STAFF REPORT: NOVEMBER 8, 2023 MEETING PREPARED BY: B. BUCKLEY APPLICATION NUMBER: HDC2023-00075 ADDRESS: 2990 E. GRAND BLVD. HISTORIC DISTRICT: JAM HANDY/NORTH END-EAST GRAND BOULEVARD HD APPLICANT: ANTHONY MORIN (ARCHITECT) PROPERTY OWNER: 2990 E. GRAND BLVD., LLC DATE OF PROVISIONALLY COMPLETE APPLICATION: OCTOBER 16, 2023 DATE OF STAFF SITE VISIT: OCTOBER 18, 2023

SCOPE: DEMOLISH EXTERIOR STAIR (WORK COMPLETED WITHOUT APPROVAL), CONSTRUCT ORNAMENTAL STAIR ENCLOSURE

Figure 3: Rendering of the proposed stair and ramp structure.

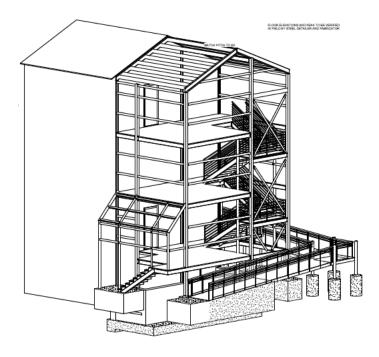
- The design of the proposed stairway does not reflect the architectural characteristics or features of the colonial revival building. However, rear egress stairs on multifamily buildings are often utilitarian structures that do not mimic the character defining features, or materials, of the main building and usually have minimal public visibility.

- The proposed structure will be minimally visible from the front of the building (along East Grand Boulevard) but will be visible from Brush Street. A four-story commercial building historically stood to the east of this property but was demolished ca. 1980. Historically, the location of the proposed structure would have been minimally visible.

- According to the Secretary of the Interior Standards for Rehabilitation, standard Number 9; "New
 additions, exterior alterations, or related new construction will not destroy historic materials, features, and
 spatial relationships that characterize the property. The new work will be differentiated from the old and
 will be compatible with the historic materials, features, size, scale and proportion, and massing to protect
 the integrity of the property and its environment." The proposed stair structure is differentiated from the

original building by its design and materials. The materials (steel, COR-TEN steel, and concrete), while not historically used in this fashion on residential buildings, are not out of place in the largely commercial and industrial Jam Handy/North End-East Grand Boulevard Historic District. The scale of the proposed structure is somewhat larger than the previous stairway, but does not overpower the original building. The continuation of the gable roof from the rear block of the building to the proposed structure helps it to blend with the massing of the original structure.

• It is staff's opinion that the proposed stair and ramp structure does not alter the building's characterdefining features. The proposed structure also does not inhibit the building's ability to convey its age, original design, or contributing status within the district.

Staff finds that the proposal for construction of the ornamental stair and ramp structure will not alter the features and spaces that characterize the property and district and therefore recommends the Commission issue a Certificate of Appropriateness for the work as proposed as it meets the Secretary of the Interior's Standards and the Elements of Design for the district.
